Drawing Title
**PASSING PLACE A2_P_8
GENERAL ARRANGEMENT**

Stage 2 Road safety audit response report

Offline Highways Passing Places – Package 2 – Oxfordshire (A3 Marsh Gibbon – Compound Access)

Stage 2 Road Safety Audit

Drawing Title
**PASSING PLACE A2_P_8
EXISTING UTILITIES AND
SITE CLEARANCE**

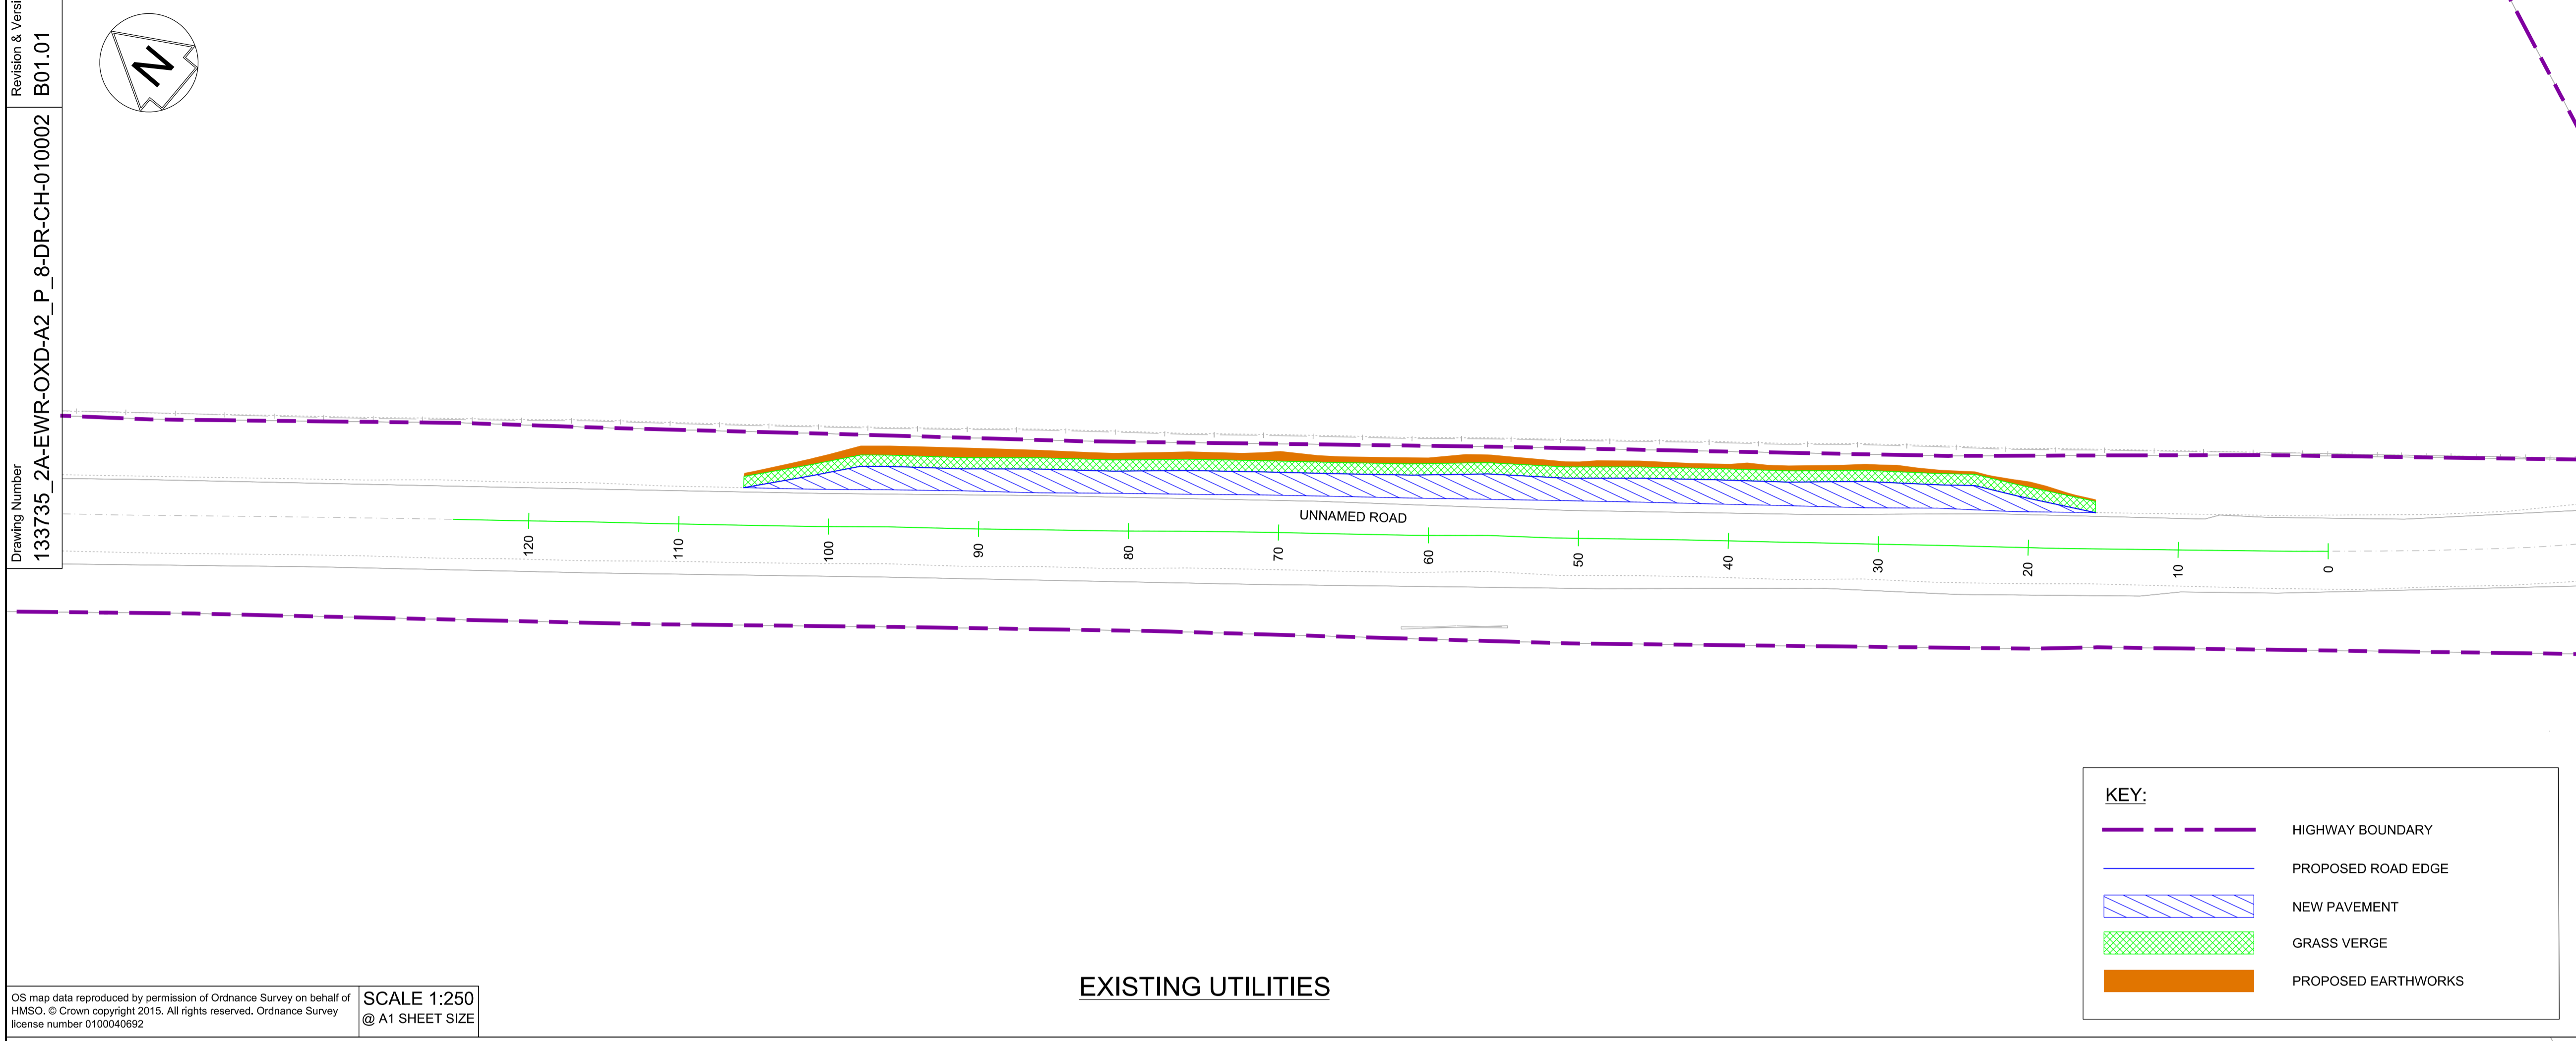
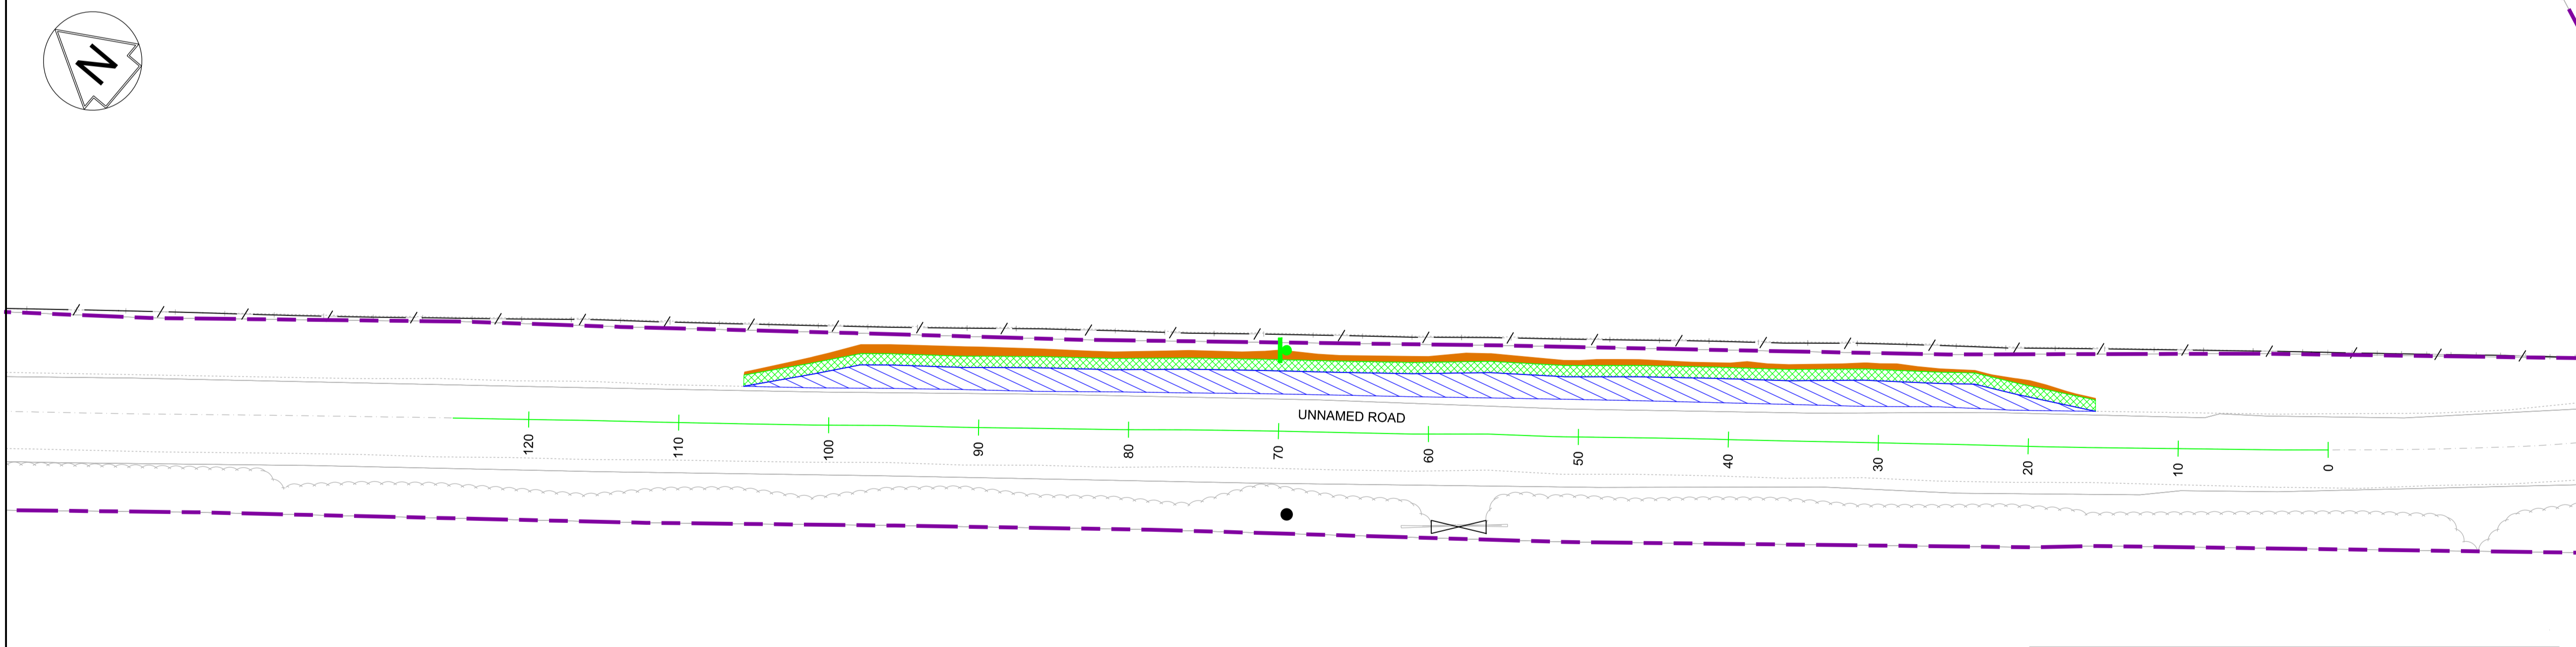
Location: Passing Place A2-P-8.
Unnamed Road (towards Mill Road).

Summary: Disused signpost increases potential severity of collision

There is a disused signpost in the nearside verge heading westbound on Unnamed Road (towards Mill Road), opposite the proposed passing place A2-P-8, which presents an unnecessary hazard to a vehicle, should a collision occur at this location. The likelihood of a vehicle striking the disused signpost is increased by the location of the passing place opposite as vehicles may pass closer to the verge to avoid construction traffic. This disused signpost may therefore lead to an increase in the collision severity should one occur.

Remove disused signpost.

2.2	Passing Place A2-P-8. Unnamed Road (towards Mill Road).	Disused signpost increases potential severity of collision There is a disused signpost in the nearside verge heading westbound on Unnamed Road (towards Mill Road), opposite the proposed passing place A2-P-8, which presents an unnecessary hazard to a vehicle, should a collision occur at this location. The likelihood of a vehicle striking the disused signpost is increased by the location of the passing place opposite as vehicles may pass closer to the verge to avoid construction traffic. This disused signpost may therefore lead to an increase in the collision severity should one occur.	Remove disused signpost.	Accept the RSA problem and recommendation made by the RSA team. The disused signpost is included for removal in the Site Clearance Drawing.	Accepted	Proceed as Design Team Response
